**MOFFETT FEDERAL AIRFIELD
CALIFORNIA**

**FINAL
INSTALLATION RESTORATION PROGRAM
PETROLEUM SITES
(AND WASTEWATER TANKS AND SUMPS)
CORRECTIVE ACTION PLAN**

November 7, 1994

FIGURE 4
MOFFETT FEDERAL AIRFIELD
SITE 5
AREA OF SOIL CONTAMINATION
ABOVE CLEANUP LEVELS

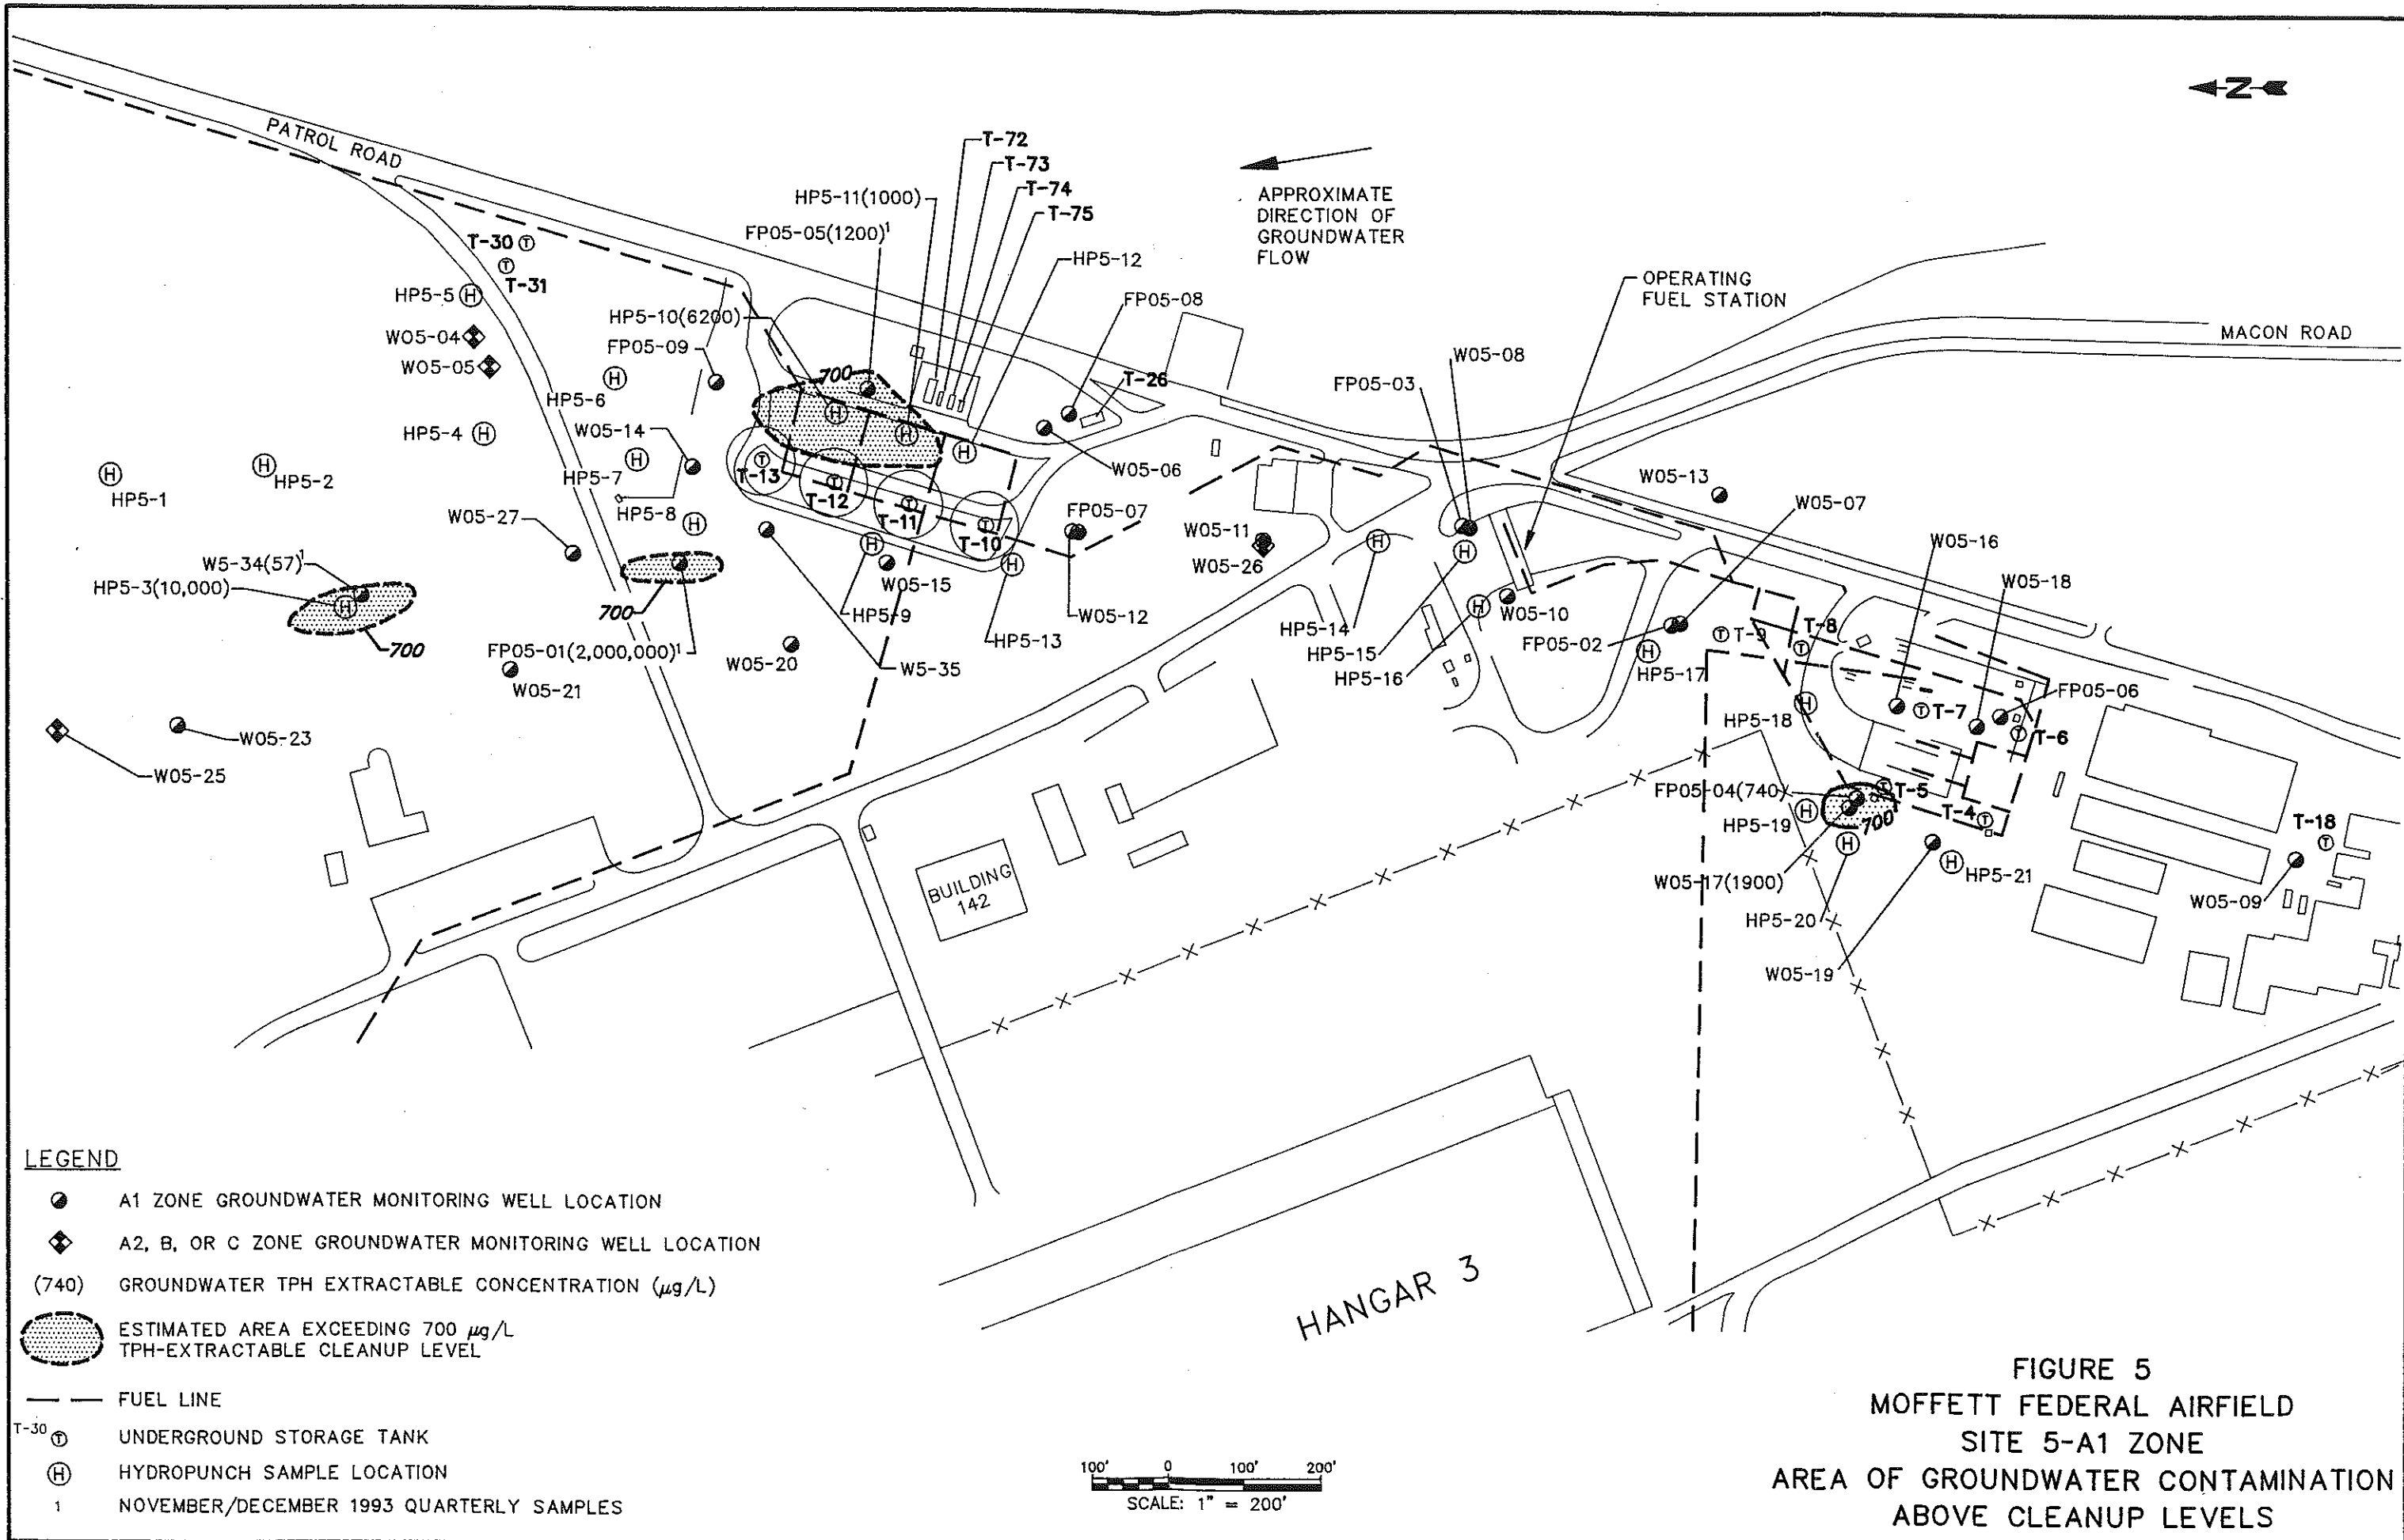
Comment 7: Section 4.1, Page 23, First Paragraph. If the soil contamination related to the Tank 26 excavation is of such limited extent that it cannot be plotted on Figure 4, this should be clearly stated.

FIGURE 6
MOFFETT FEDERAL AIRFIELD
SITE 5 PALEO CHANNEL MAP

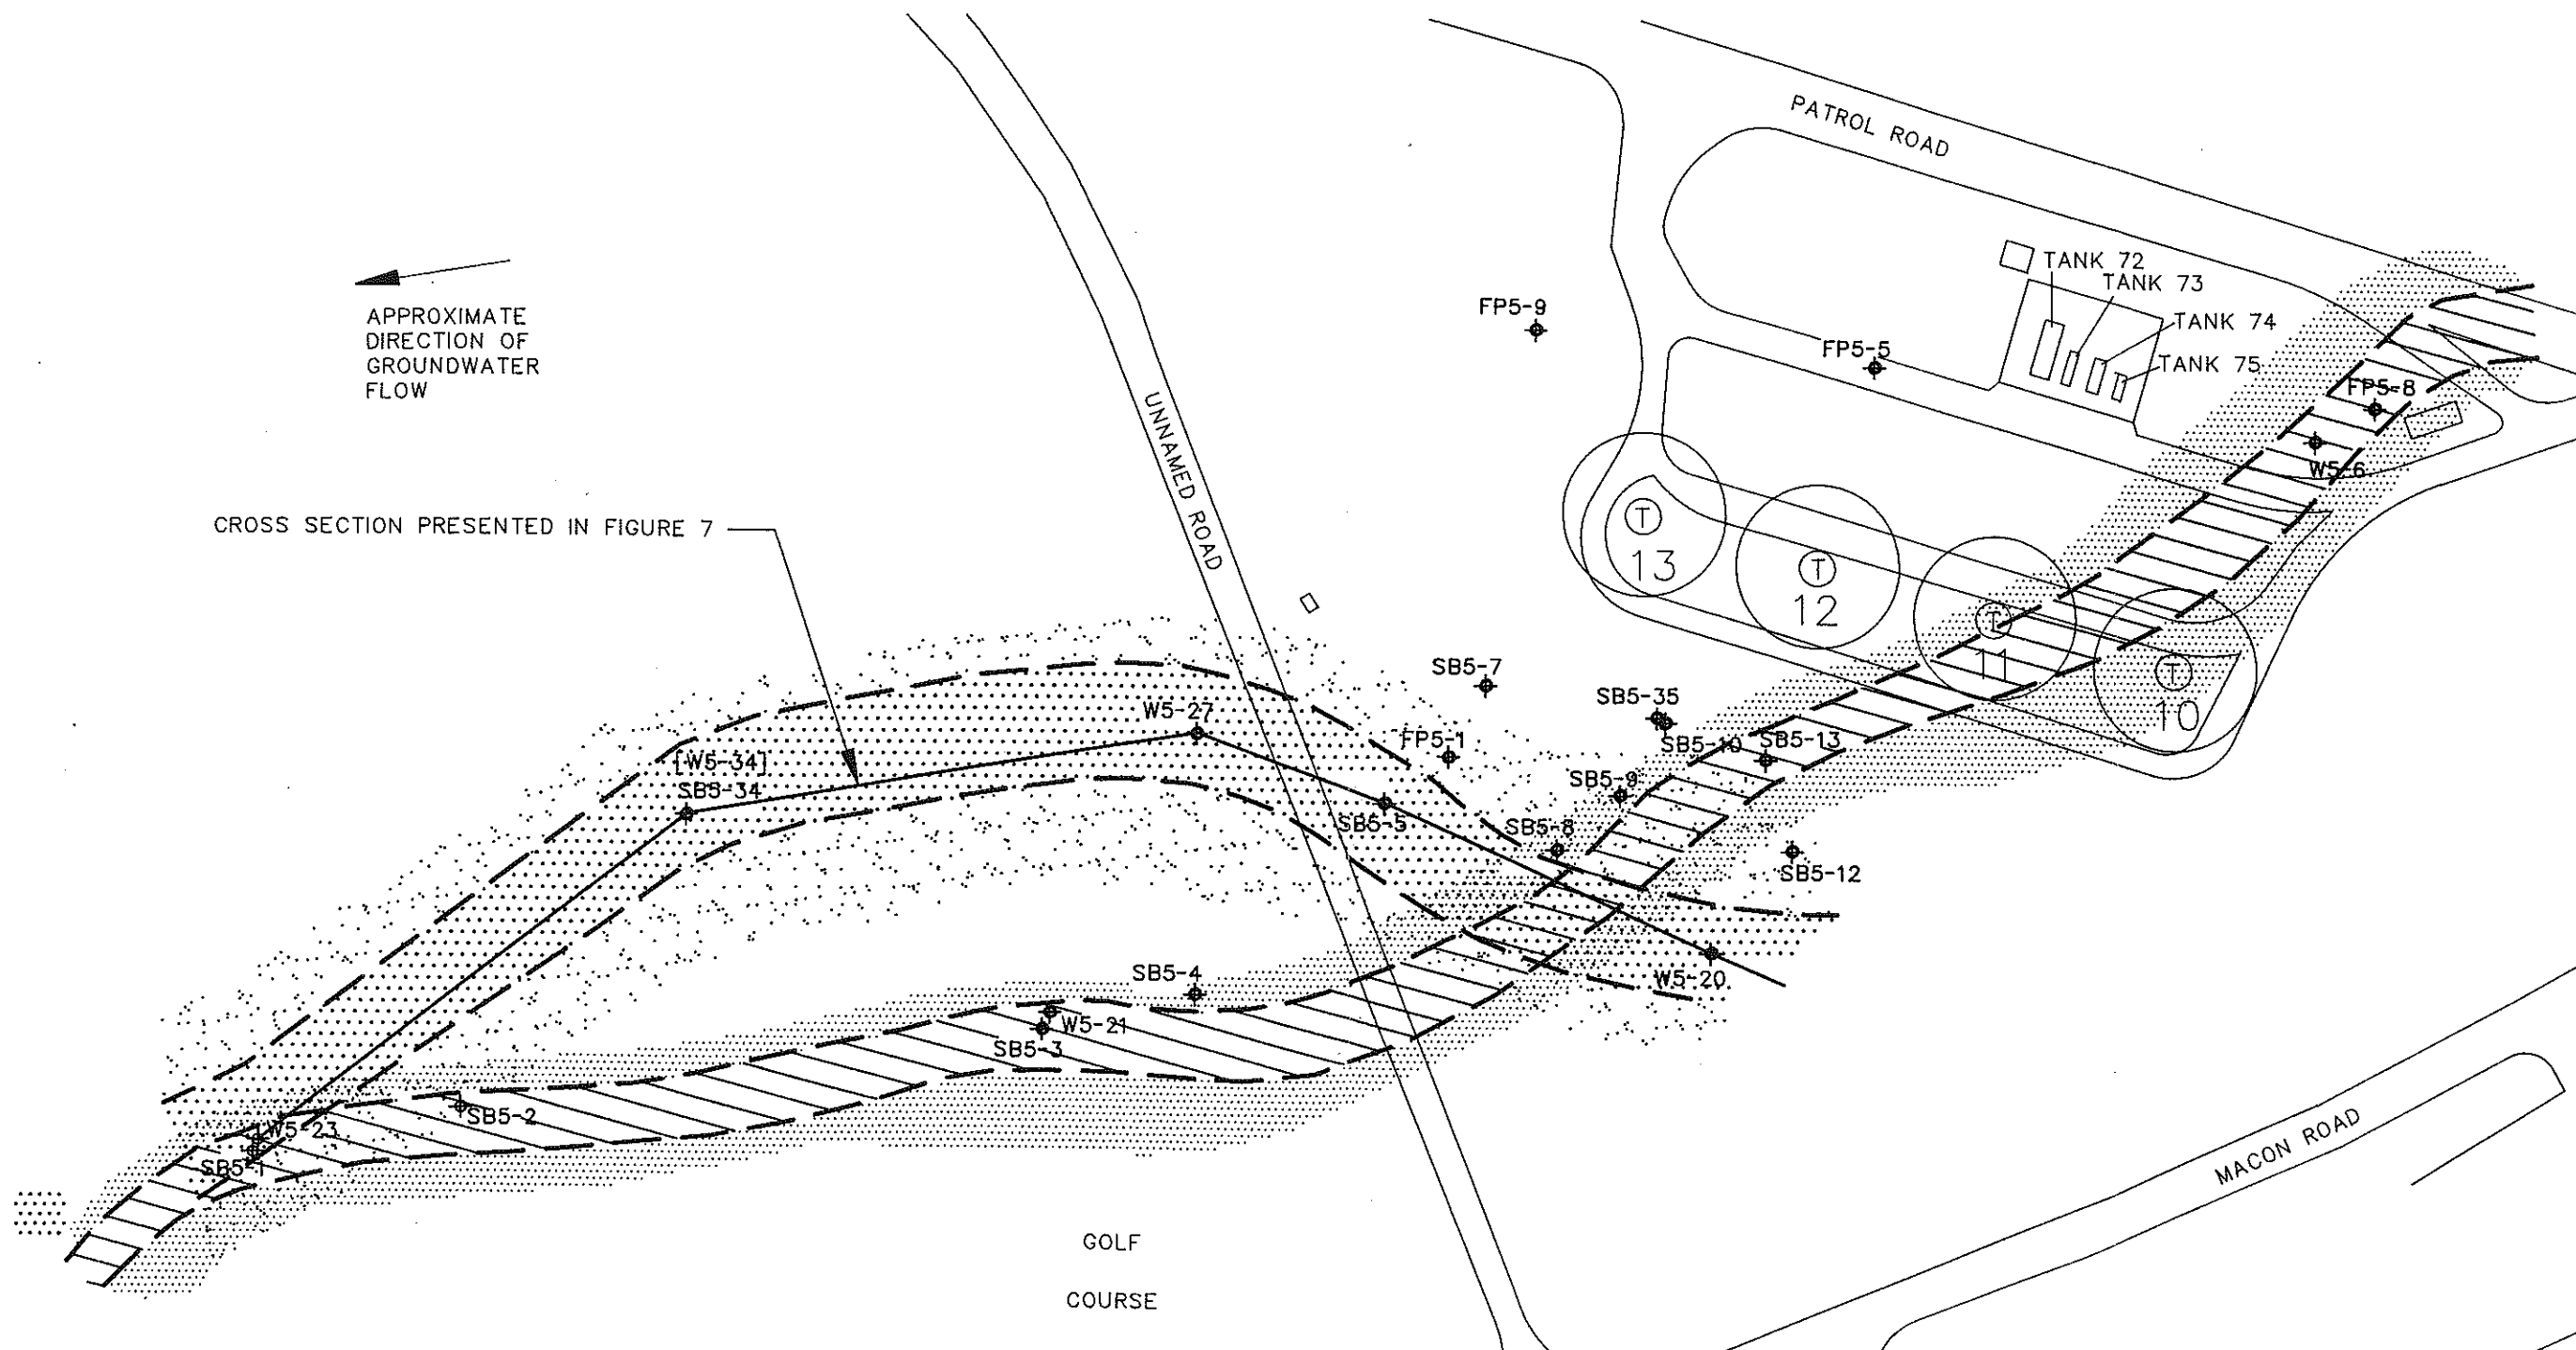
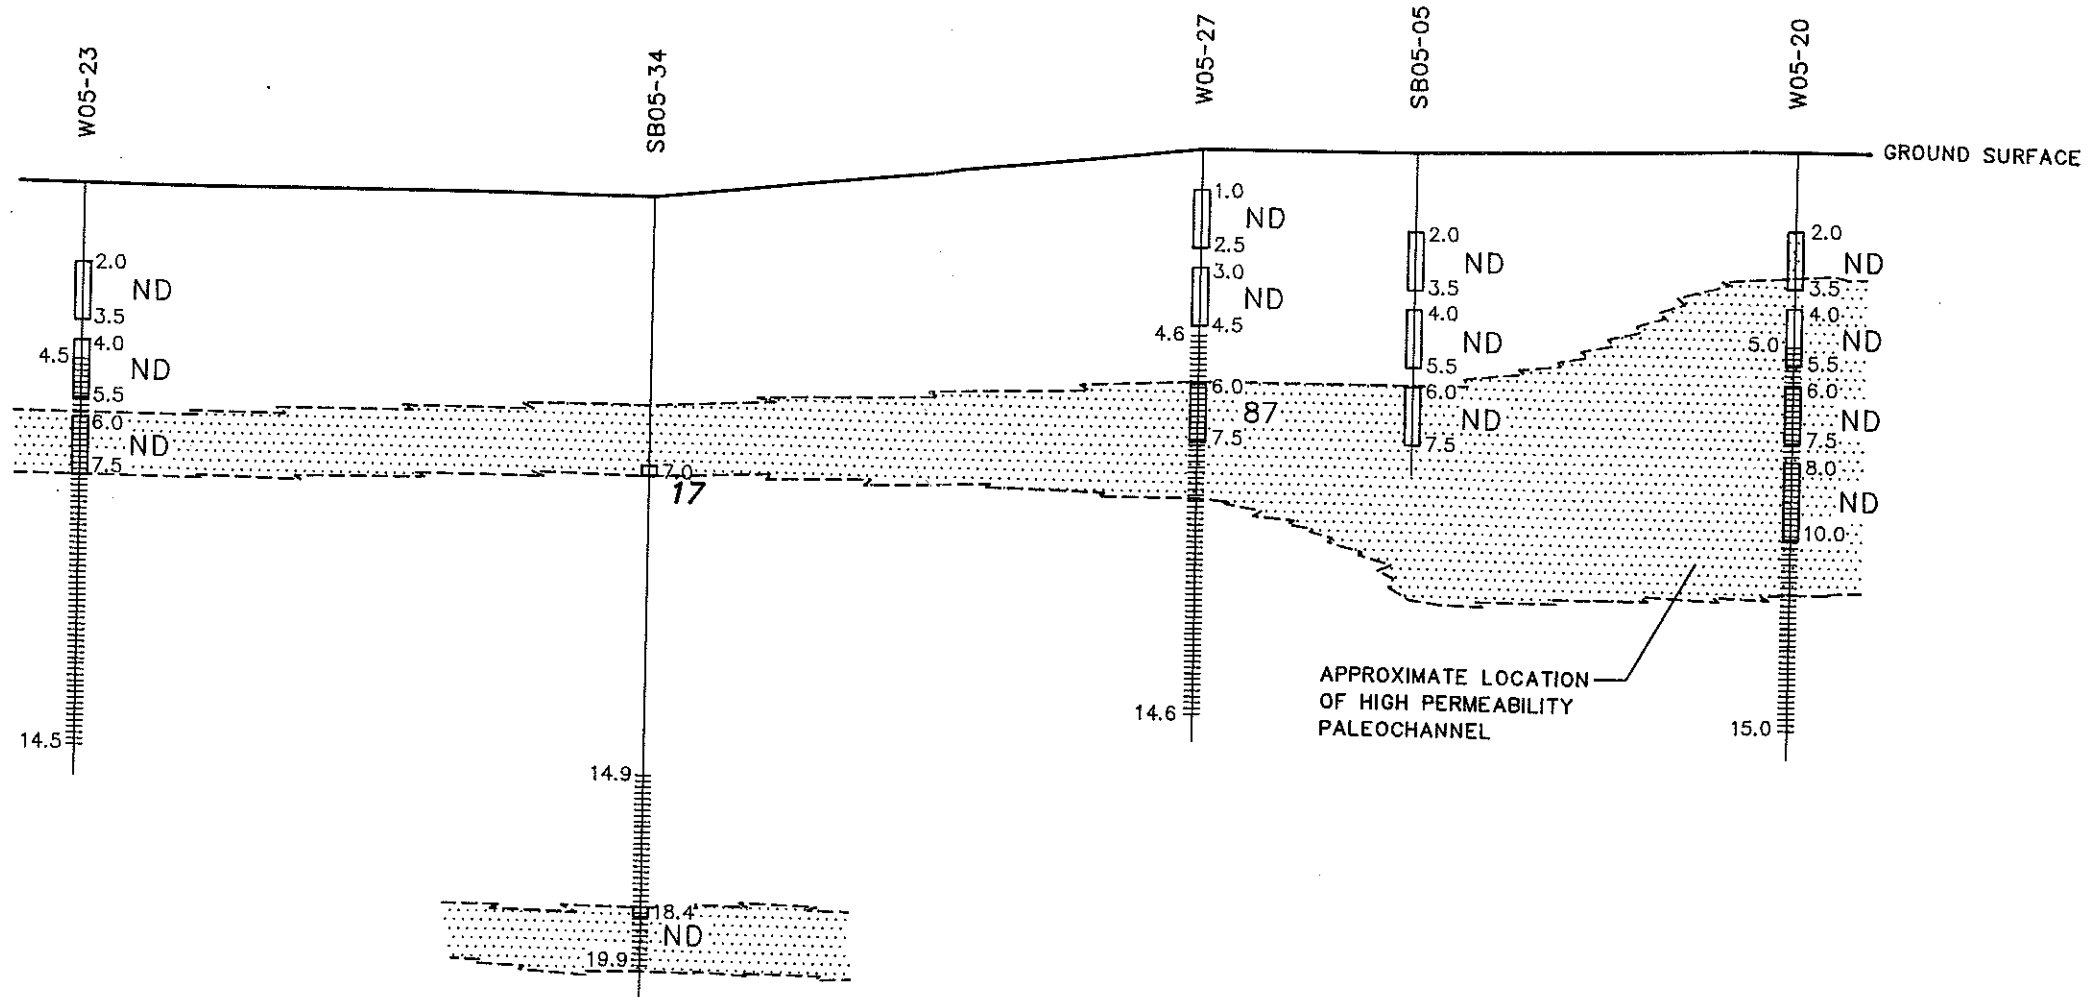
Comment 8: Section 4.1, Page 23, Third Paragraph. Does the channel discussed here extend toward HP5-3 and well W5-34? The change in scales between Figures 5 and 6 and the lack of reference points of Figure 6 makes this unclear.

Response: The channel deposit discussed in this paragraph and shown on Figure 6 does extend toward HydroPunch® sample HP5-3 and monitoring well W5-34. The reference point on Figure 6 is soil boring SB5-34, which is the boring that well W5-34 was constructed in. Well designation W5-34 has been added to Figure 6 for clarity.
